Product Change Notification

Change Notification #: 115454 - 00

**Change Title: Intel® Dual Band Wireless-AC
3168 SKUs 3168.NGWG;
3168.NGWG.S,
PCN 115450-00, Label Change**

Date of Publication: April 17, 2017

3168.NGWG Before:

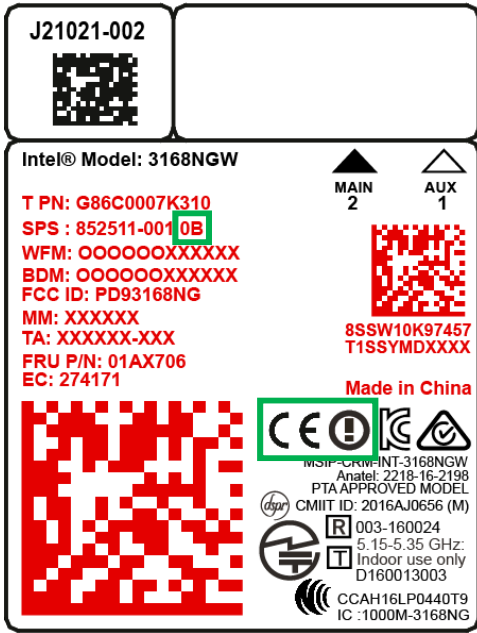
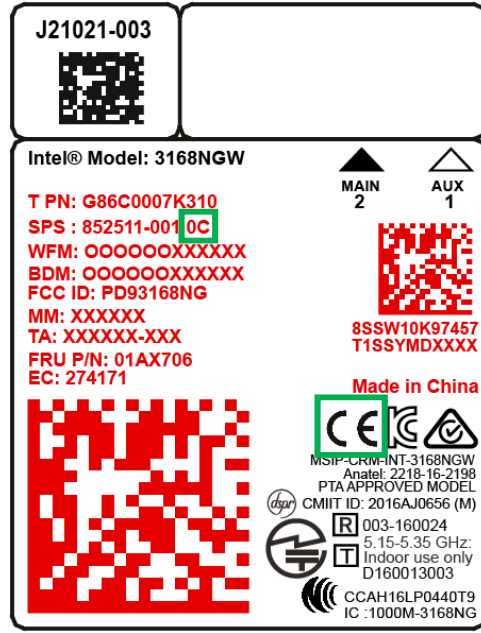
1. The current CE ! Mark on the module label will be modified to remove the Alert Symbol (!) following the CE mark.
2. We will be adding 2 graphics to the outer packaging to be visible by EU customs.
 - a. A new CE graphic:
 - b. The Intel Corporate address
